ND-10-0023

Southern Nuclear Operating Company
Vogtle Electric Generating Plant Units 3 and 4 Combined License Application
Response to Request for Additional Information Letter on Environmental Issues

Response to NRC RAI Letter Dated December 10, 2009

VEGP Units 3 and 4 COL Application

Enclosure Attachment 3

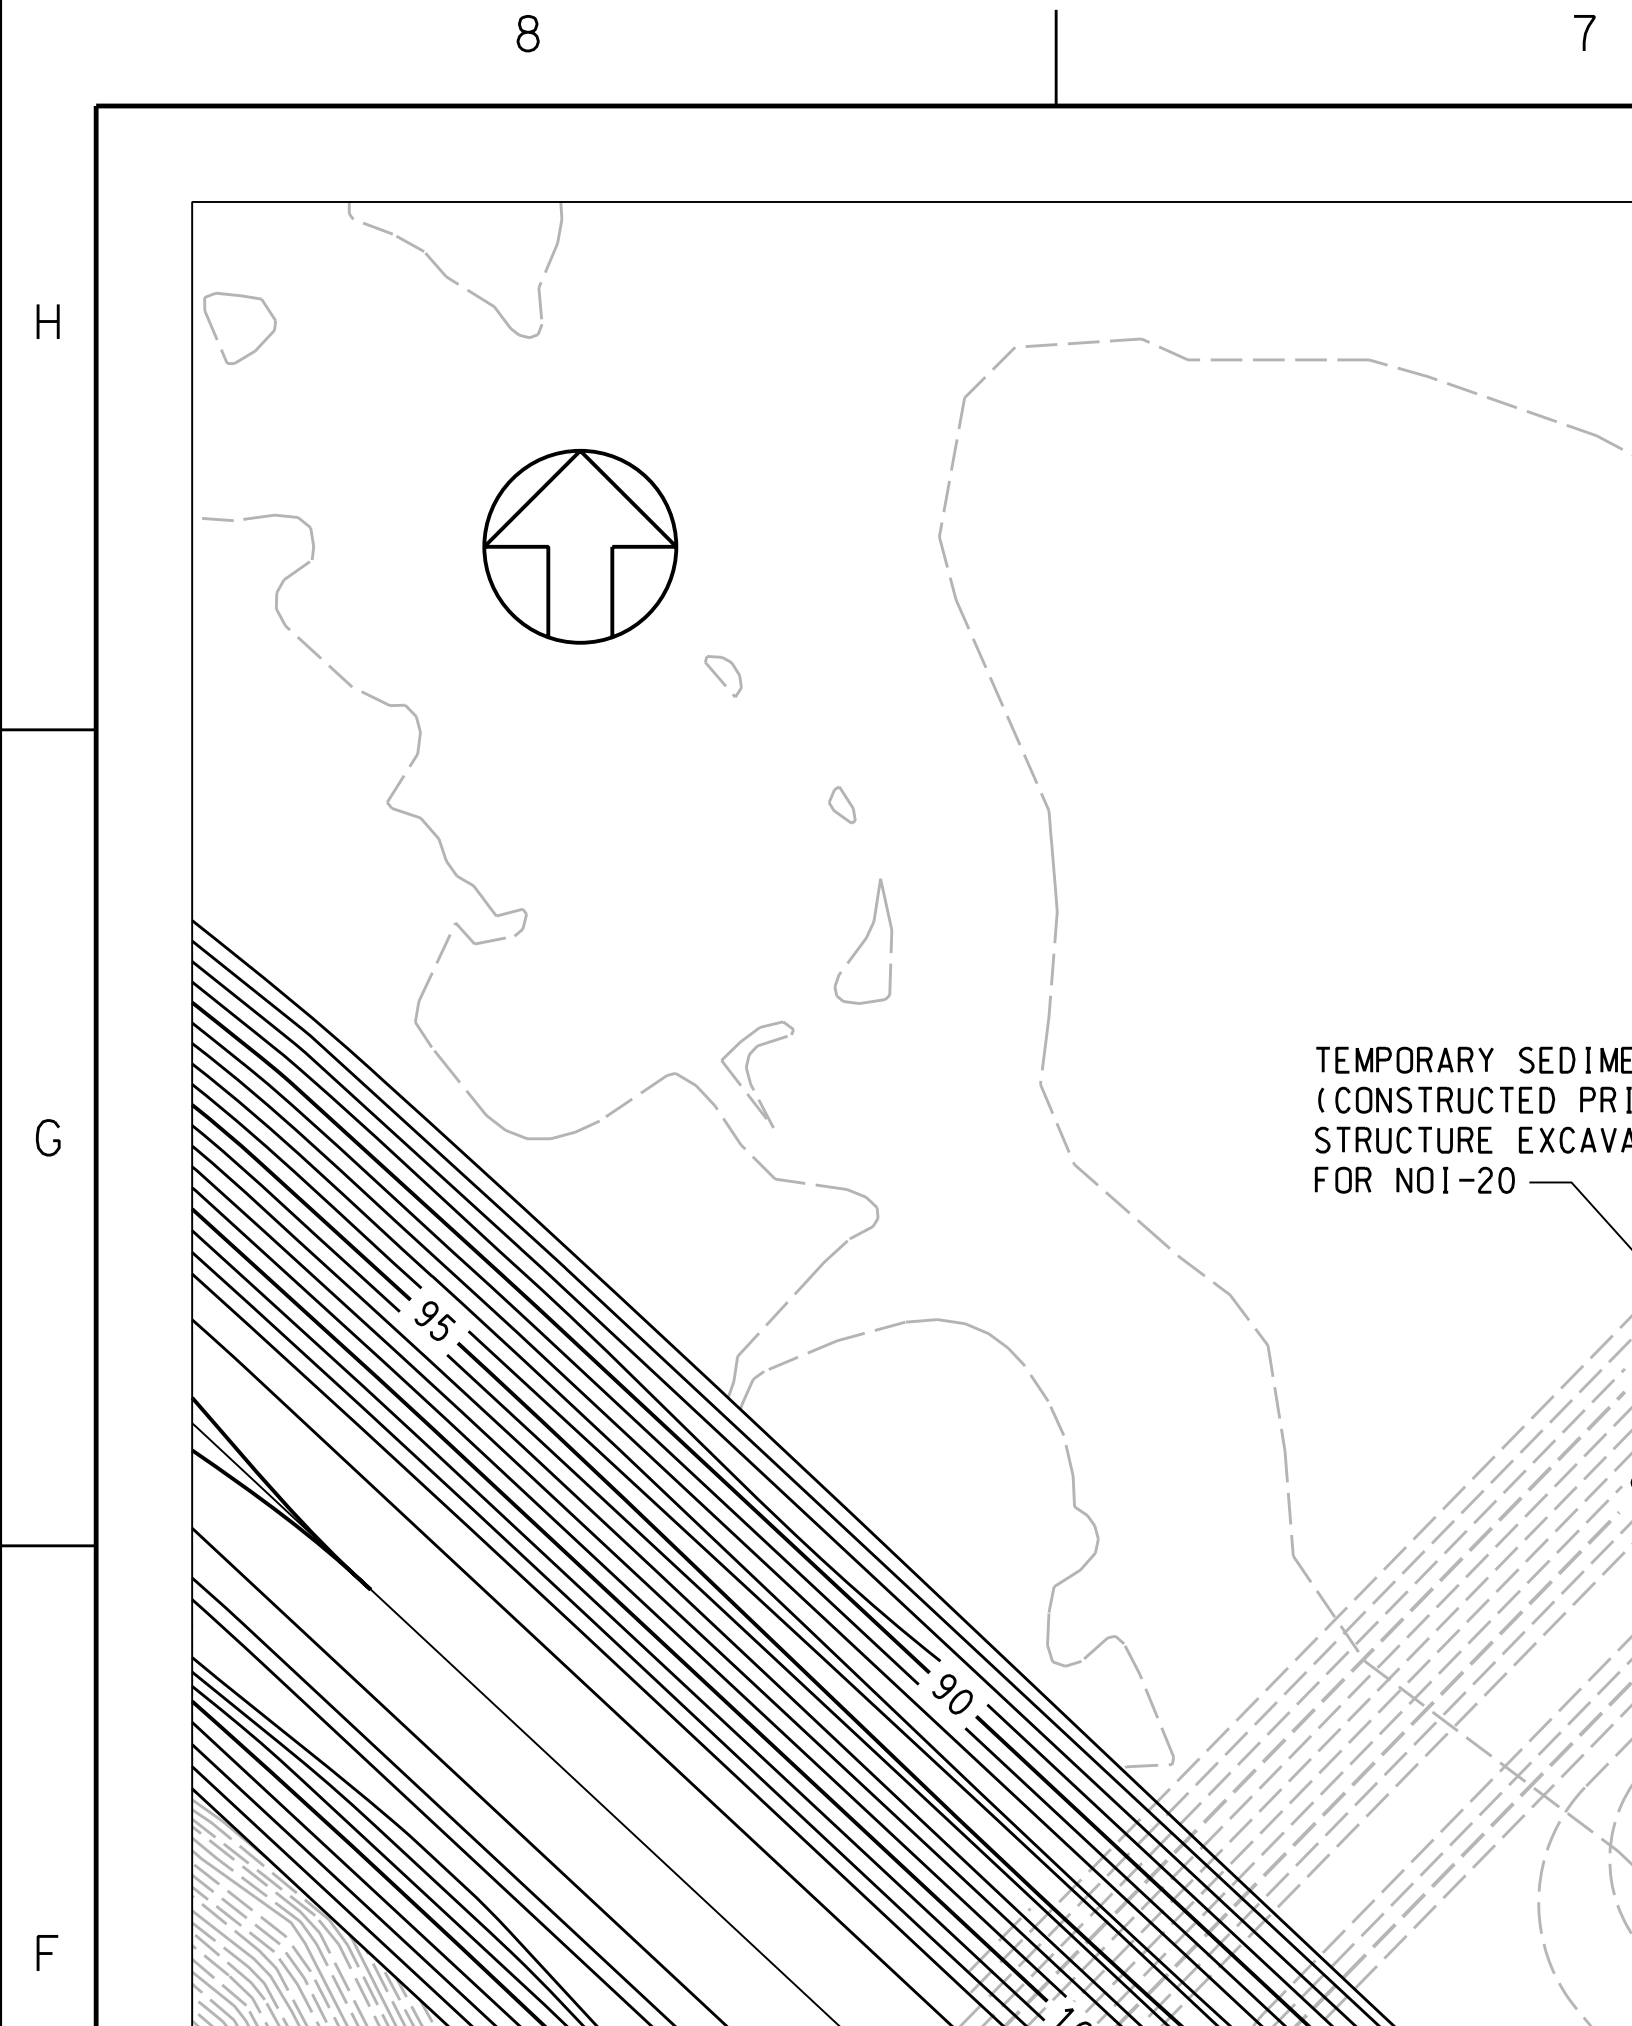
RAI Number	RAI	Additional Background Information
AE 5.4.2.2 ESRP 4.3.2 which refers to ESRP 3.1; and 3.4.2	If SNC has seen any fluctuations in water level in Mallard Pond since the excavation, describe any mitigation plans if water level changes. If SNC intends to alter the location of the proposed intake canal and structure, describe the new location, including the distance to the Mallard Pond outlet stream and to the existing intake canal for Units 1 and 2. If any design changes are planned to the intake structure, intake canal, and/or intake screens, provides a description of how these design changes might affect the flow and flow rate of water and ichthyoplankton into the structure. Include a description of any specific structures that are to be installed to selectively pull water from specific parts of the water column, as well as a description of the movement of water as a result of these structures, an indication of whether the design changes will impact the entrainment or impingement of the aquatic organisms and the magnitude of these changes, and whether the design changes would affect the hydraulic zone of influence.	During the discussions at the site audit, the NRC/PNNL staff was told that the intake floor would be lowered in a new design.

The cooling water intake structure has been moved upstream approximately 150 feet and rotated slightly from the location considered in the ESP FEIS. These changes were recommended by Shaw Group to improve the constructability of the intake structure and to align the intake structure with the bluff. The new Intake location is located approximately 2130 feet upstream of the existing Units 1 & 2 intake and approximately 1400 feet downstream of the outlet to the unnamed tributary of Mallard Pond. A figure showing the preliminary layout of the intake structure and canal is included in Attachment 3 to this Enclosure. (Cont'd.)
